Re: **Former Cattle Dip**
Road Reserve bordered by Lots (2) Irrelevant 3 on RP863054 and Logan River
Chambers Flat, Queensland

To the Date:
From CHRISTOPHER DOUG:
Subject Review - Site Validation Report
Remediation & Validation of Road Reserve
Part of RPS63054, Chambers Flat.

Site Validation Report

REMEDICATION AND VALIDATION OF ROAD RESERVE
PART OF R.D. 863054

Depths of Remediation Excavation

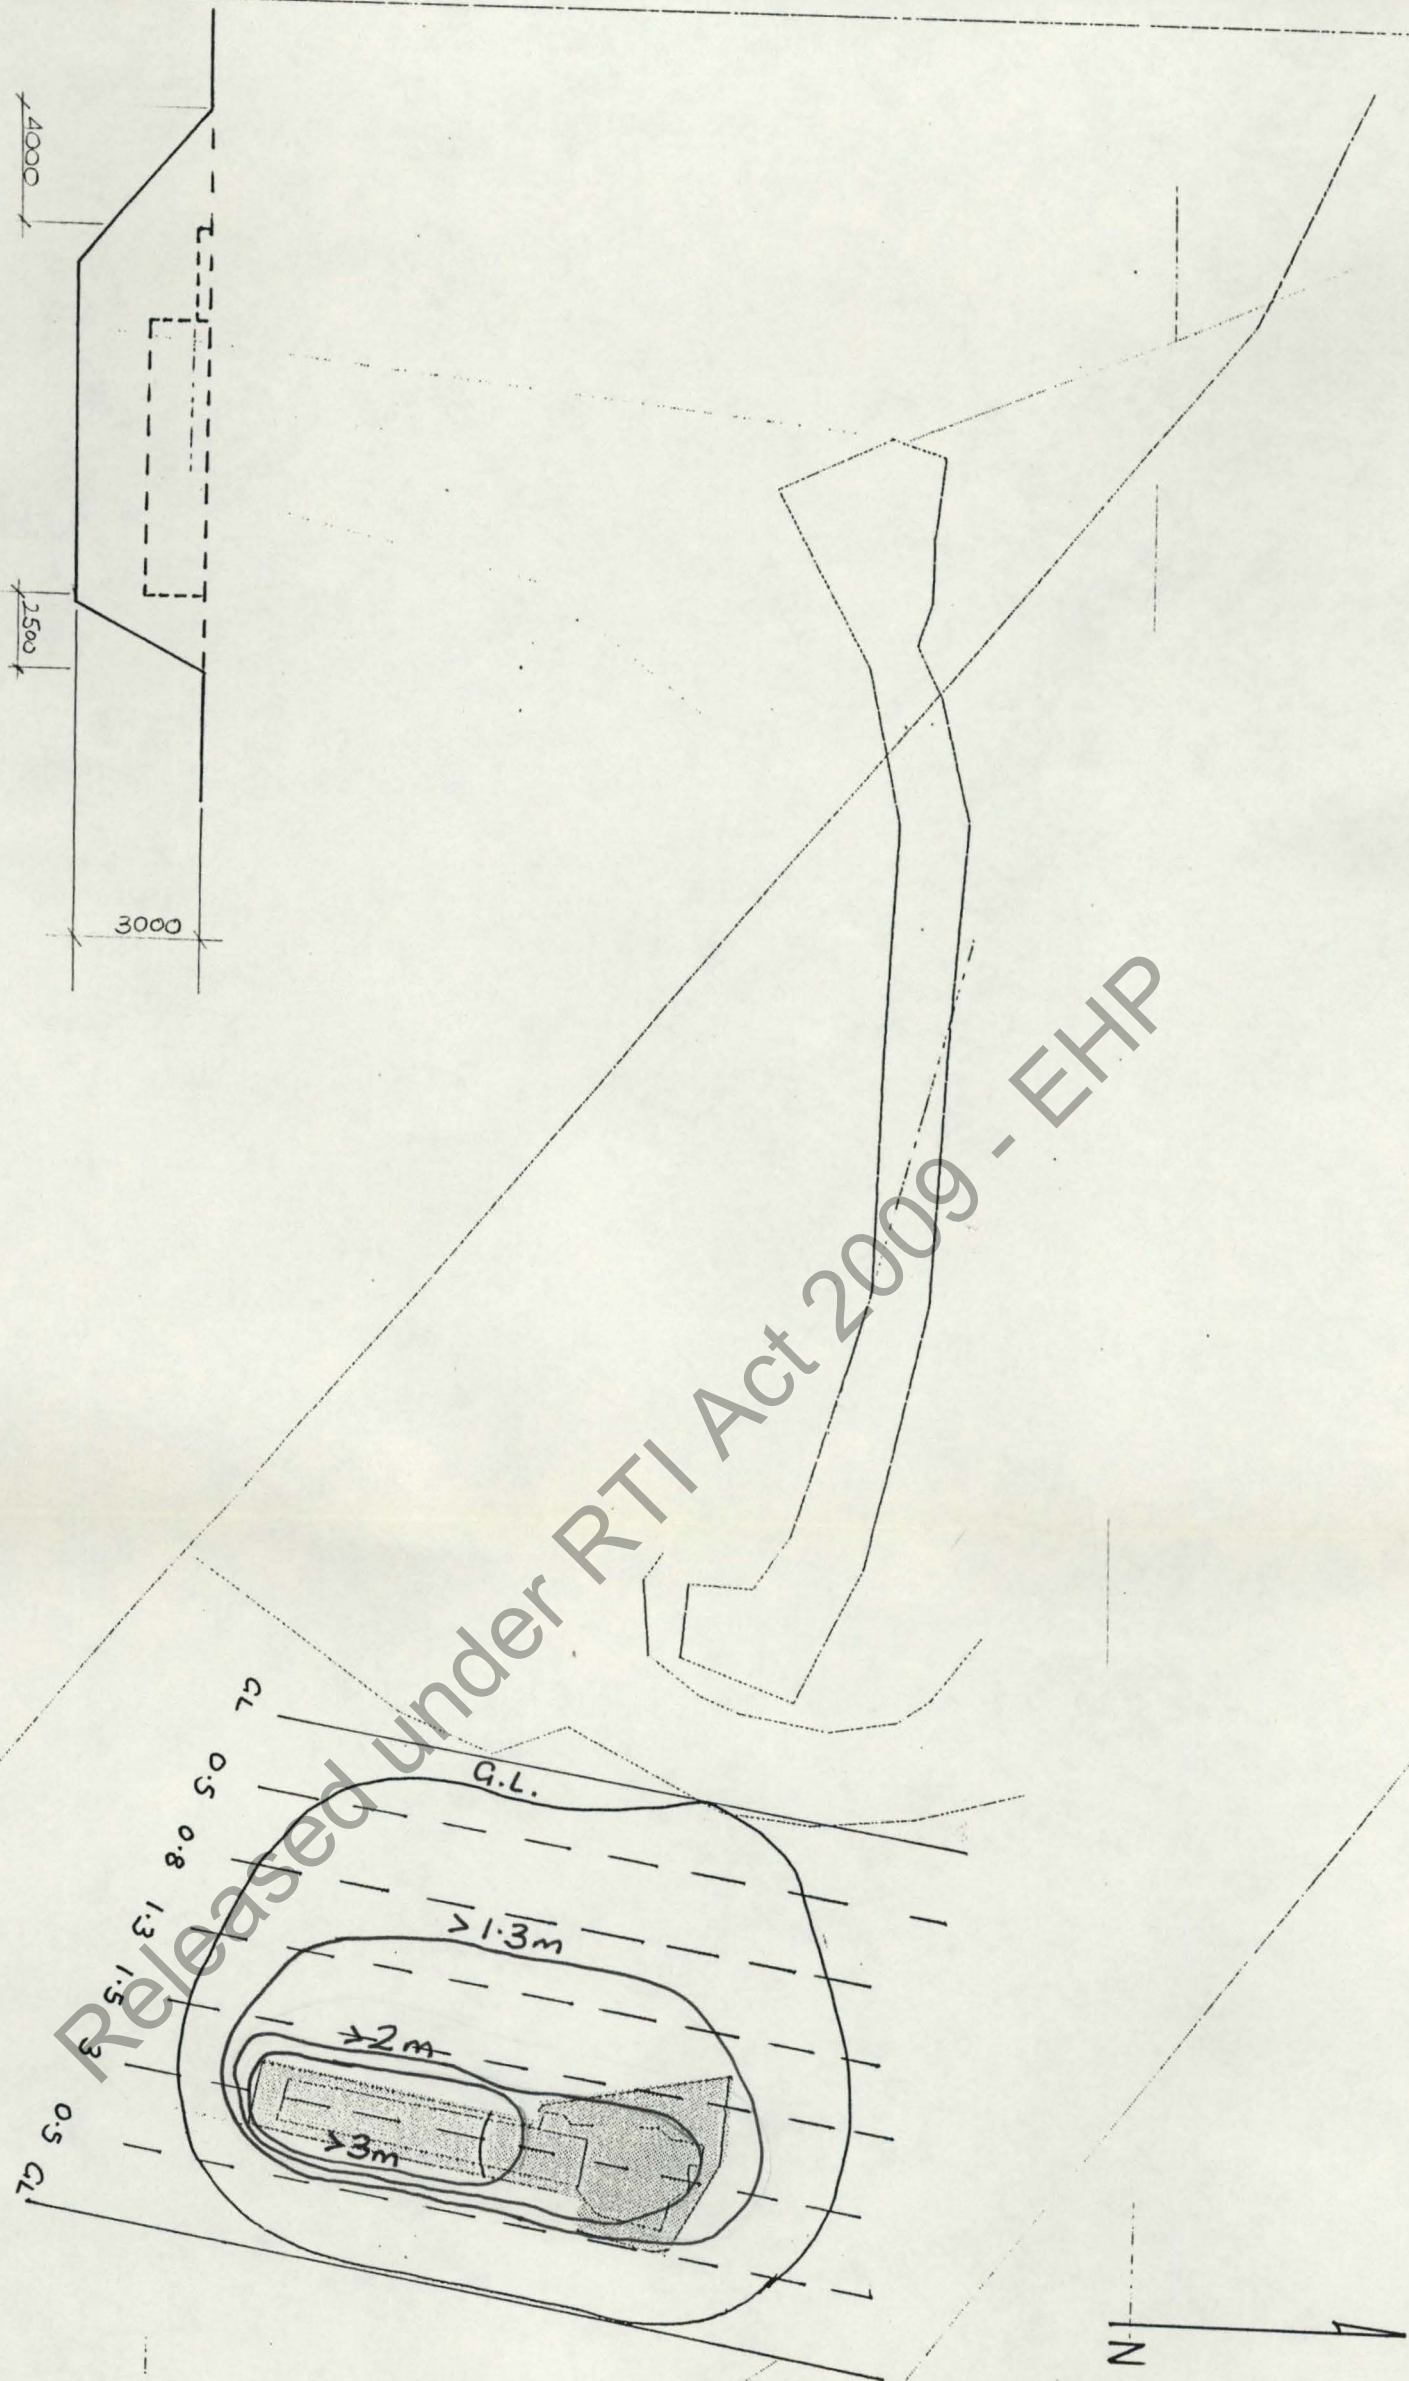
- In the vicinity of samples 1 to 5, a significant excavation wall exists. It is considered that there may be potential for contamination of the excavation wall between the depth of 0.5 and 3.0 metres, please comment on this with relation to dip structure, and soil strata observed in the excavation walls. Based on dip structure is there any potential for contamination not sourced from leakage from the base of the dip or splash and overflow from the surface.

- In the vicinity of samples 1 to 5, a significant excavation wall exists. It is considered that there may be potential for contamination of the excavation wall between the depth of 0.5 and 3.0 metres, please comment on this with relation to dip structure, and soil strata observed in the excavation walls. Based on dip structure is there any potential for contamination not sourced from leakage from the base of the dip or splash and overflow from the surface.

Is this final contours.
Yes. ? Based on depths of samples

Based on the condition of the dip at the time of excavation it is considered unlikely that contamination of the site would have originated from any source other than surface contamination from spillage and from leakage of the dip. At the time of remediation the dip was intact and held a quantity of water.

It is considered that contamination is limited to the top strata of soil in this case. Below this first layer is a clay layer with a very high plasticity. This layer of soil is believed to effectively contain the arsenic contamination. Based on these observations it is believed that contamination of the site has been removed to below Department of Environment threshold levels.

Validation Sample Points 14th
December, 1995

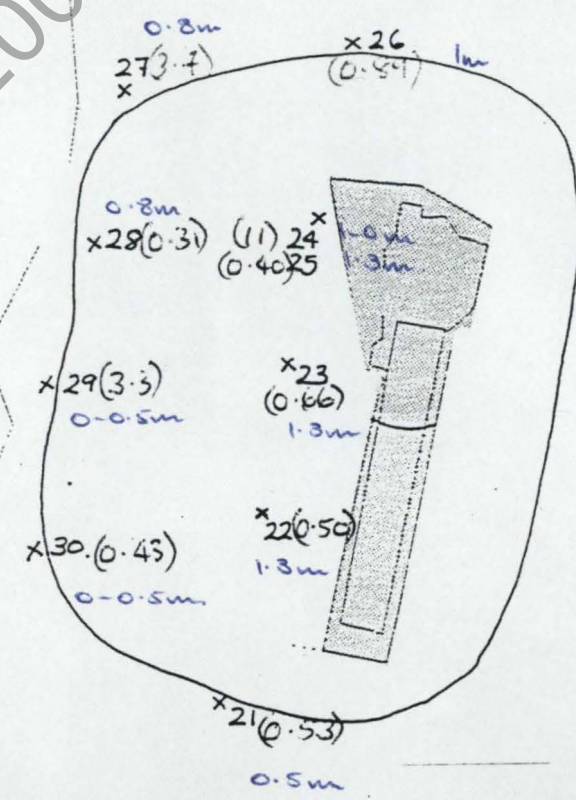
- In the vicinity of samples 9, 13, 14 and 15 it is understood that excavations were extended vertically to remove arsenic contaminated soil. Were excavations extended laterally in these areas. Please explain how samples collected to date validate the lateral extent of excavation. Are samples h, i and f considered as validation samples of surface soils in these areas.

- In the vicinity of samples 9, 13, 14 and 15 it is understood that excavations were extended vertically to remove arsenic contaminated soil. Were excavations extended laterally in these areas. Please explain how samples collected to date validate the lateral extent of excavation. Are samples h, i and f considered as validation samples of surface soils in these areas.

Went deeper but did they go wider.

Excavations validated by depth
No surface validation to NW & South.
Samples originally collected in these areas

OK.
mahl shows
hairs & e
Scale
map showing all
old samples that are
used to validate surface
lateral extent.

Excavations in this area were also extended laterally in the vicinity of samples 9, 13, 14 and 15. In this instance excavation of the site came to within 800mm of the previous samples h and i. In this case the samples h and i were intended as validation samples. With respect to validation in the vicinity of assessment sample f the excavation was taken to this site. This information was inadvertently omitted from the initial report.

PLATE 3b

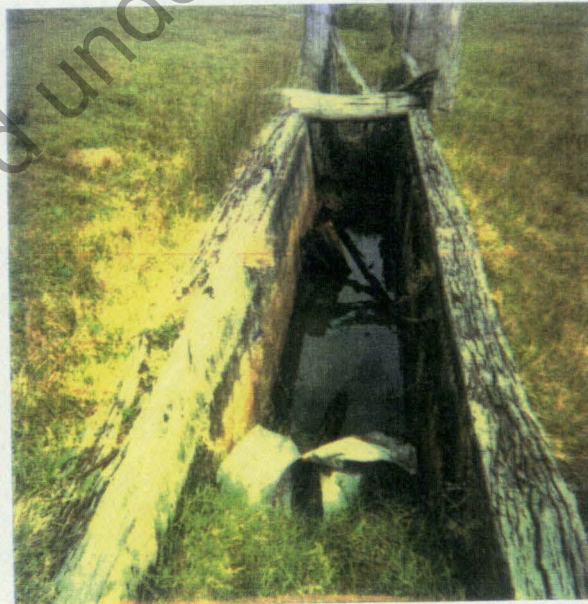
See photo 3b reheat 1.?
